Great Karoo Wind Energy Facility and associated infrastructure, Northern Cape Province

Motivation for amendment of Environmental Authorisation

DEA Ref.: 12/12/20/2370/3

April 2019

Figure 1: Layout Map for Great Karoo WEF presented for the amendment dated 25 July 2016 (A3 Map included in **Appendix H**).

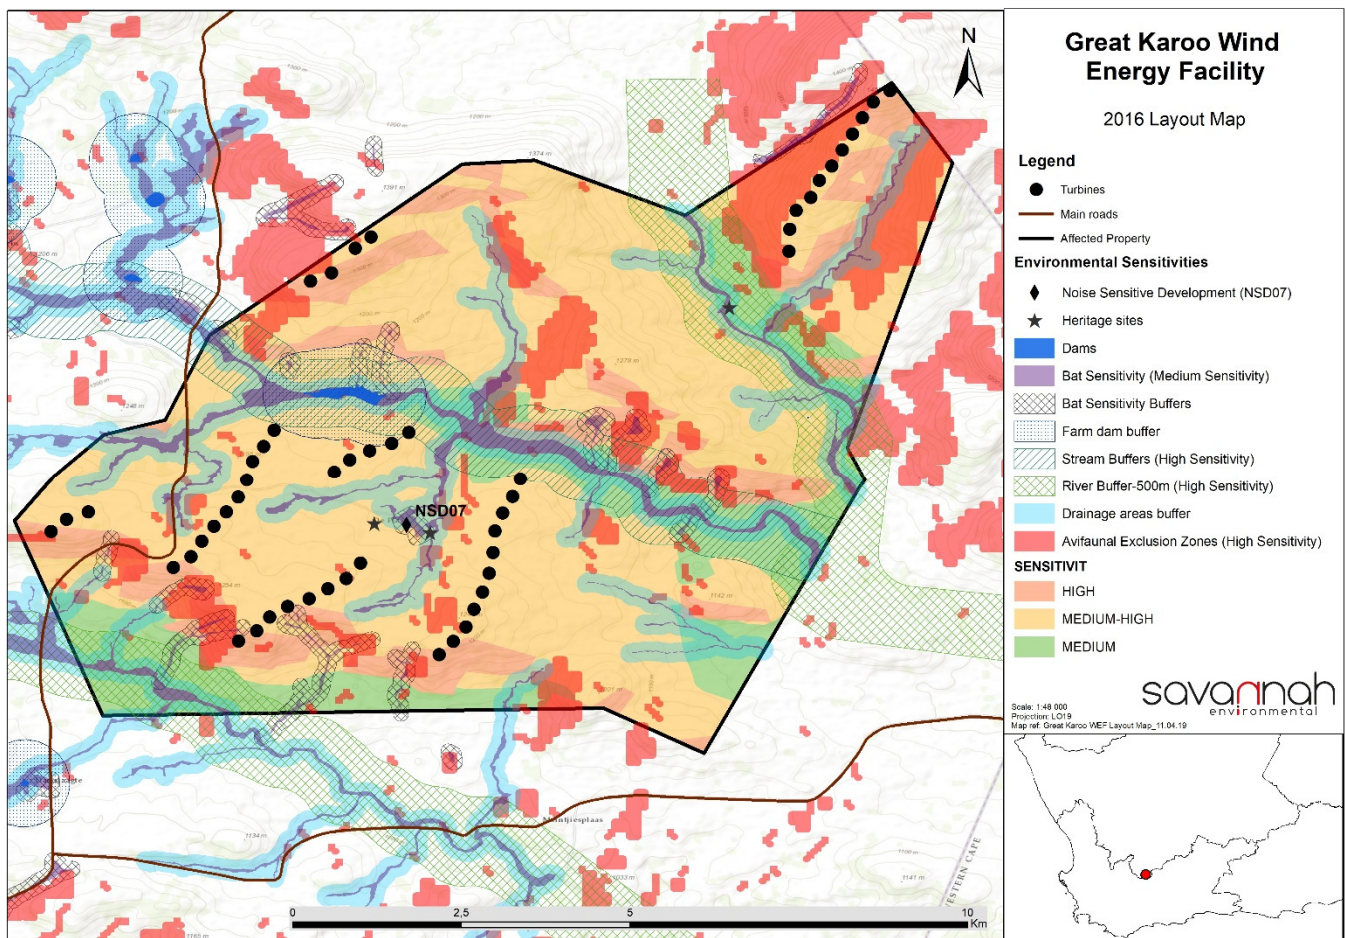
The layout presented for the amendment issued in July 2016 is presented below. It must be noted that this layout was not approved and therefore a final layout is still required to be submitted in accordance with Condition 13 of the EA dated August 2014.

Figure 2: Updated wind farm layout - A3 Map included in **Appendix H.**

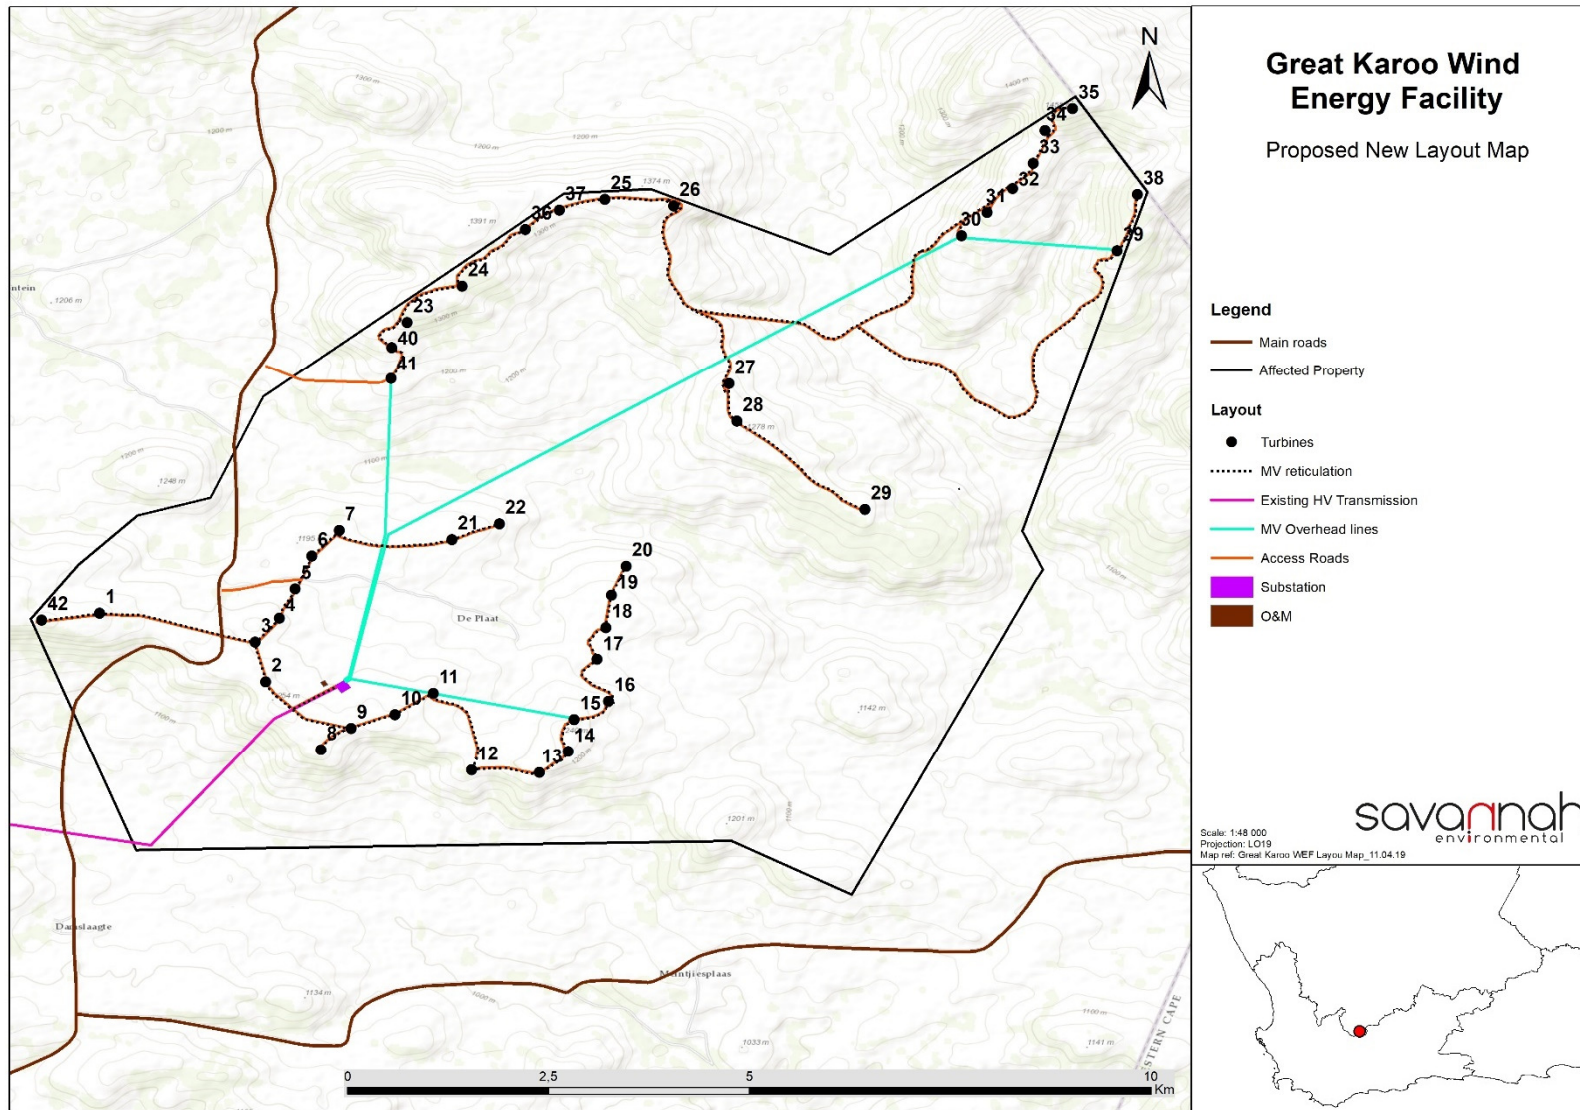
The number of wind turbines is proposed to be decreased from the authorised 52 turbines, to 42 turbines. It is therefore requested that the project description in the amended EA dated July 2016 be amended to include the correct maximum number of turbines to be installed at the site as follows (amendments shown in **Bold** text):

"...up to **6.5MW** in capacity and with up to **180m** rotor diameter and a hub height of up to **150m**

This proposed amended layout is presented in Figure 2. It must be noted that this layout will be finalised and submitted to the DEA for review and approval (in accordance with Condition 13 of the EA) once a turbine supplier has been selected for the project.

Figure 5.3.1. Sensitivity map of the Great Karoo WEF site, depicting the amended layout of the facility as considered within this amendment, overlaid onto the original sensitivity map of the site as produced by Hoare (2014).

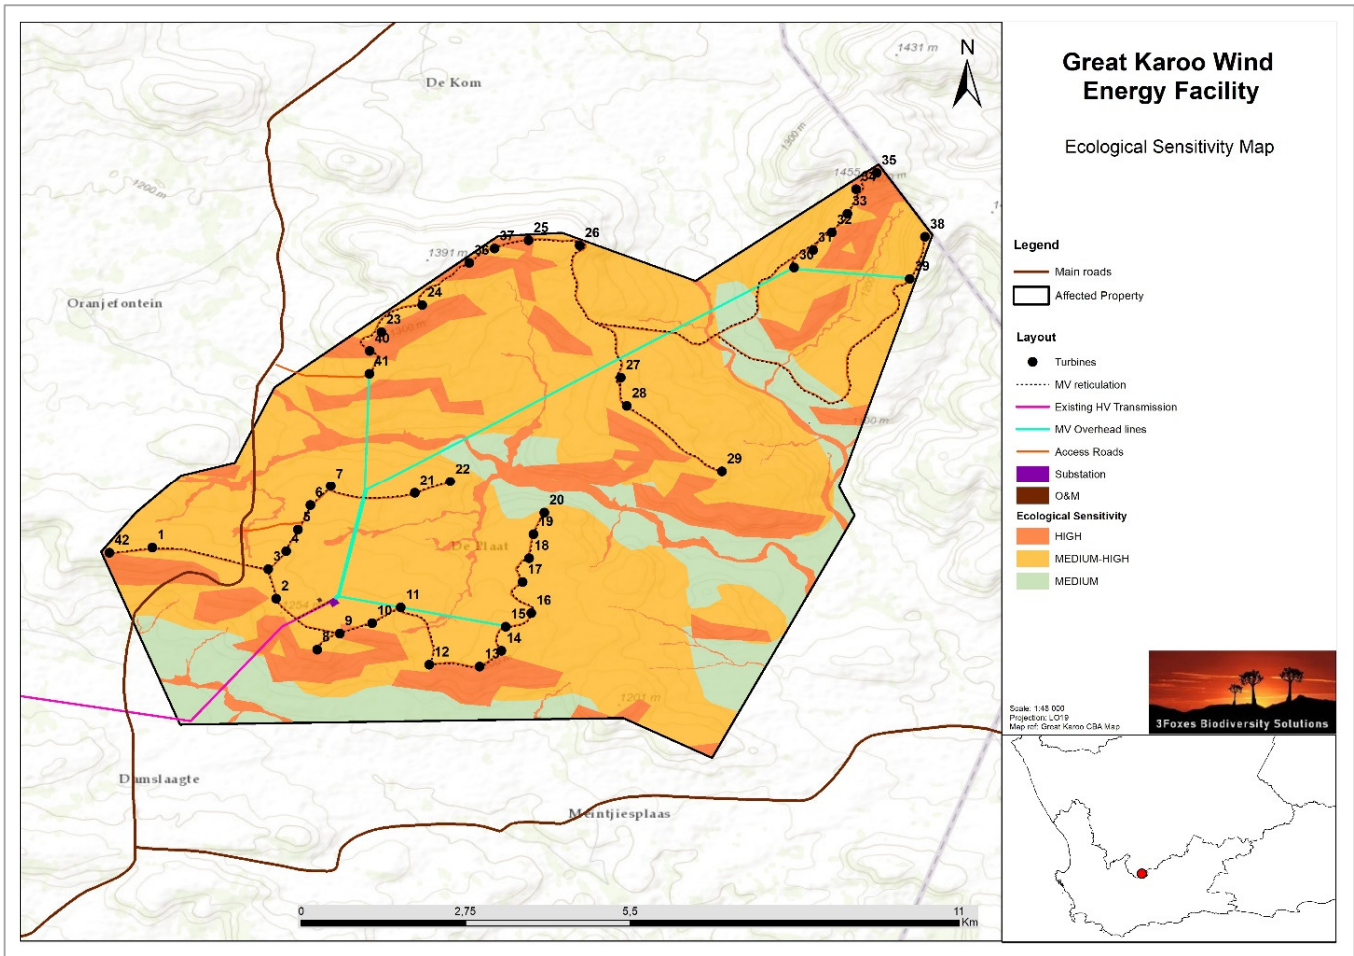
In terms of the original sensitivity map produced for the site, the ecological impact of the current proposed turbine layout would be similar or slightly lower than the most recent approved 52 turbine layout (Figure 5.3.1). The distribution of turbines, access roads and other infrastructure in relation to the assessed sensitivities of the site (Hoare, 2014) are similar and an increased impact on the high sensitivity parts of the site **is not likely**.

Figure 5.5.1: Comparative Viewshed Analysis – Great Karoo Wind Energy Facility.

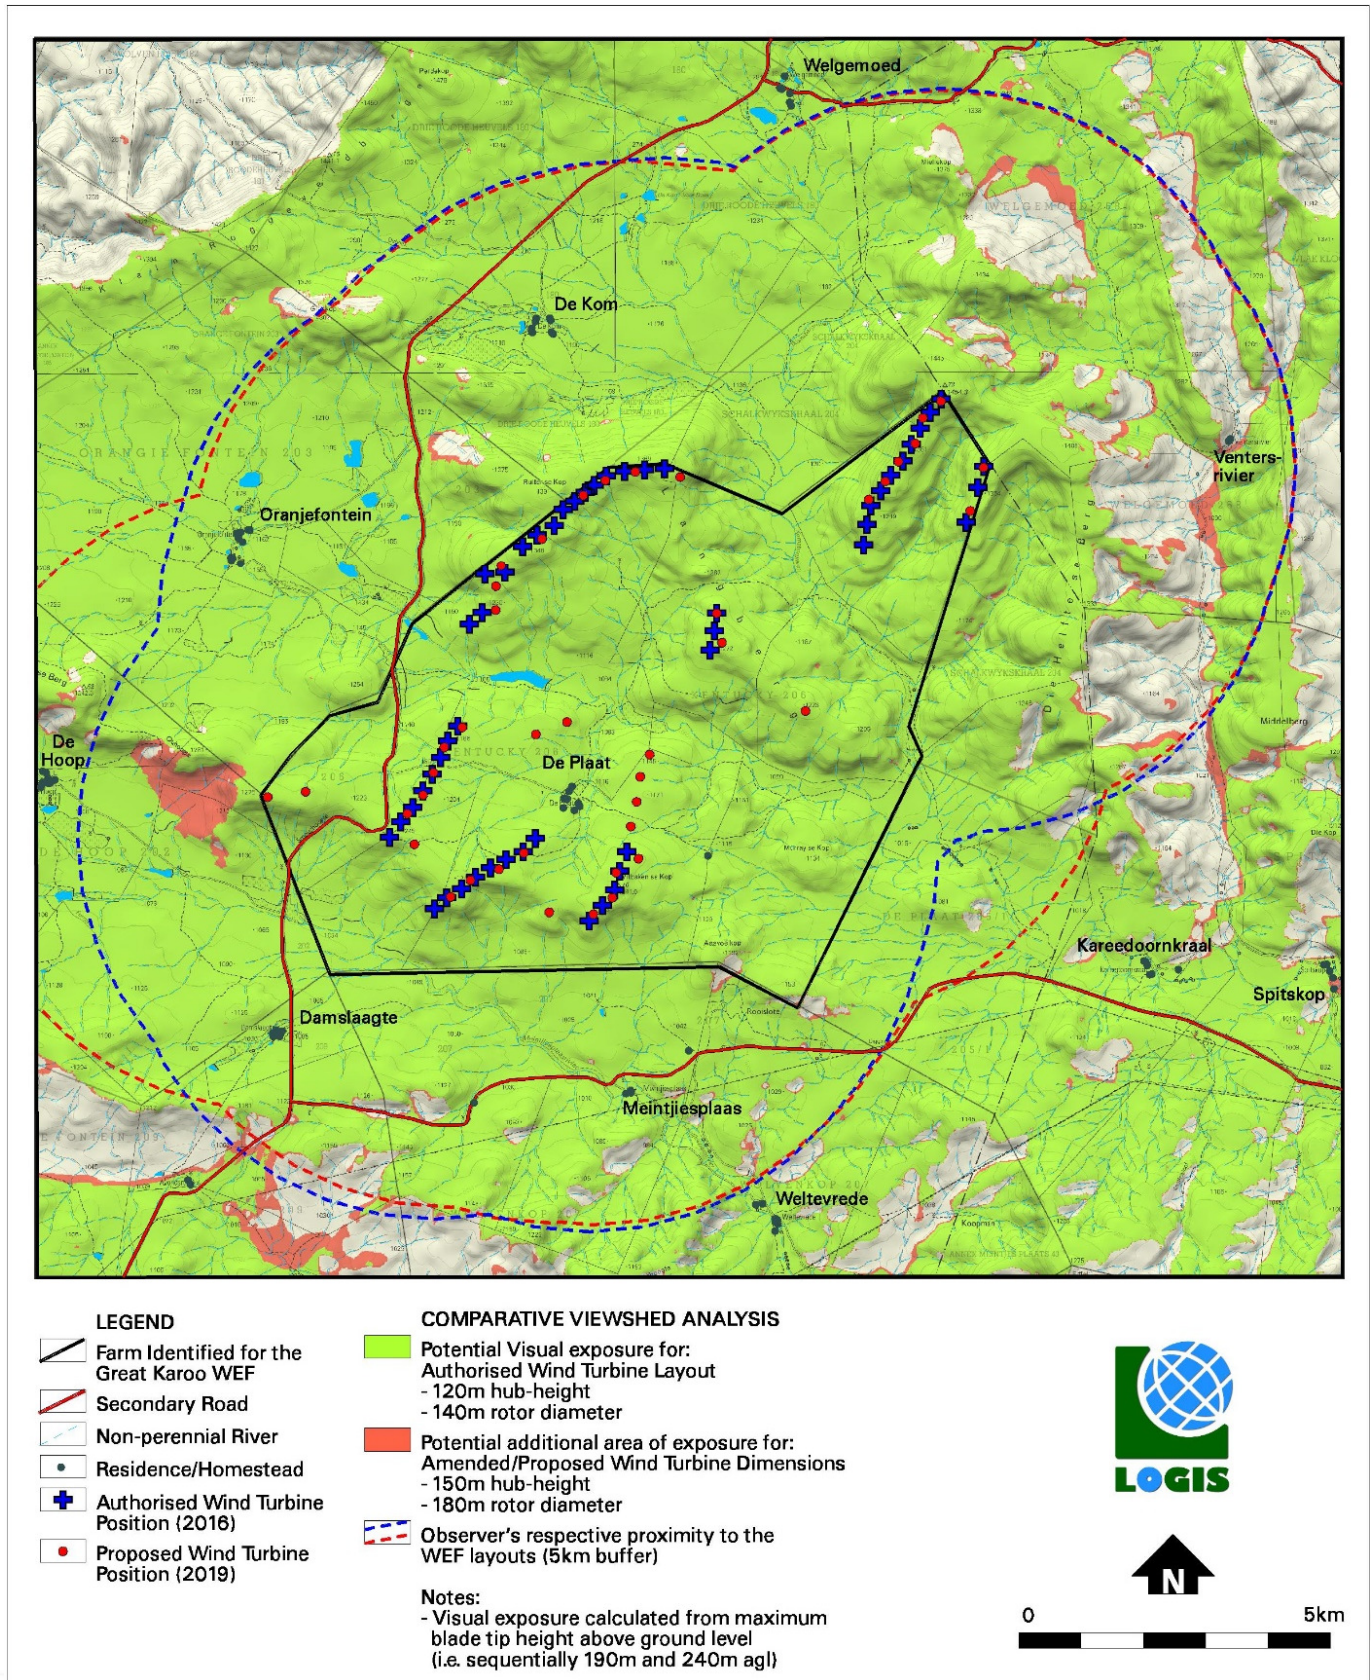
It is clear that the approximately 21% increase in turbine dimensions, would have a relatively small influence on the overall visual exposure, due to the already tall turbine structures previously approved and the elevated positions of the turbines on ridges. The surface area (within the study area) of the original turbine exposure is 345km², compared to the 354km² of the increased dimensions of the wind turbine exposure. This is an increase of 9km², or alternatively, an increase of less than 3% in potential visual exposure.

In consideration of the proposed amendments, there is no (zero) change to the significance rating compared with the original EIA visual impact assessment report. This is due to the negligible change in visual exposure of the turbines as shown in Figure 5.5.1.

Figure 9.1: Updated wind farm layout with specialist environmental sensitivities (A3 Map included in **Appendix H**).

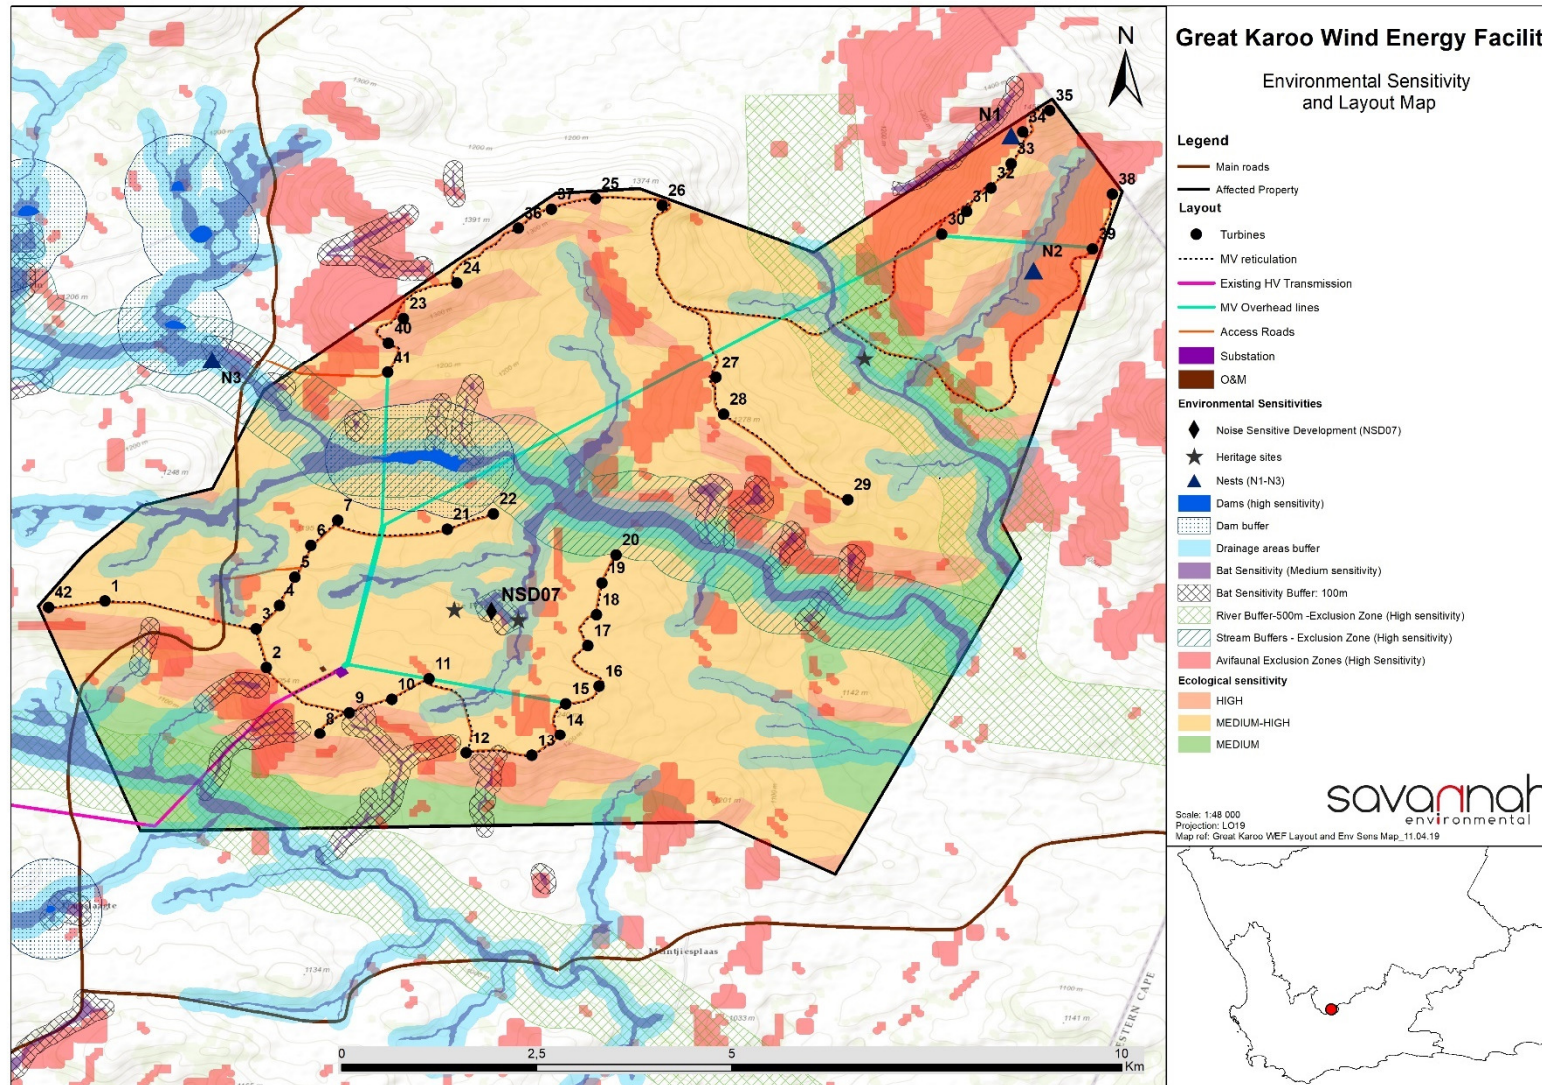
In addition, the amended wind turbine positions considered avoids all identified avifaunal exclusion zones and areas of high sensitivity (refer to Figure 9.1). One turbine, turbine 39, remains in the avifaunal exclusion zone. The avifaunal specialist concluded that this is unlikely to result in a significant increase in the overall collision impact rating of the site and that the location of this turbine is acceptable. It was recommended that fieldwork be done in the eagle breeding season to determine the activity status and species utilising the three nests recorded on site. These results must inform possible additional mitigation measures and the final micro-siting of the layout, which will be submitted to the DEA for approval in terms of the requirements of Condition 13 of the EA dated August 2014. Operational phase bird monitoring programme was also recommended by the avifaunal specialist (in line with the guidelines applicable at the start of the operational phase).
